## Historic District Review Committee

Staff Report  
November 15, 2010

**CAPP 2010-0022 Jespersen Residence: Window Sash Replacement in the Goose Creek Historic District. PIN 458-30-2108.**

Figure 1: Subject property, 38134 Hunts End Place  
. New garage and porch not depicted.

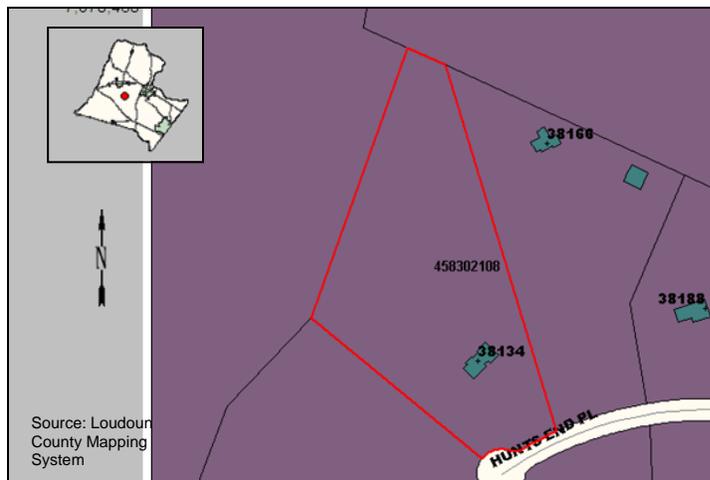
those sashes in the shed roof dormer above the garage. Photo 1 shows a representative window sash proposed for replacement. The existing window sashes are wood and have external muntins. The muntin width is approximately 1 inch. They are double hung with a 4/1 configuration. The frames are also wood. The windows in the garage dormer, part of construction approved under CAPP 2009-0012, match this configuration but are vinyl clad windows with exterior muntins as approved

The proposed replacement windows are the same 4/1 double hung, vinyl windows denied by the HDRC on August 9, 2010. However, the window manufacturer, "Champion Window" has provided the applicant the opportunity to use the vinyl window with applied 1 inch, contoured internal and external muntins to replicate a simulated divided light (SDL) window consistent with the Guidelines. The representative from Champion Windows will bring a sample of the window with the proposed muntins to the November 15, 2010 HDRC meeting for the Committee's consideration.

The proposed vinyl window replacements still do not meet the Goose Creek Guidelines. However, since the house was constructed in 1993 and is situated in a late 20<sup>th</sup> century suburban development where vinyl has been approved as a building material previously, the HDRC may find that the use of vinyl windows in this instance will not have a negative visual impact on the streetscape or on the District. Further, from the public right of way, the proposed windows will not be visually distinguishable from vinyl clad windows which are acceptable per the Guidelines.

1. All replacement windows will have exterior and interior 1 inch dimensional muntins.
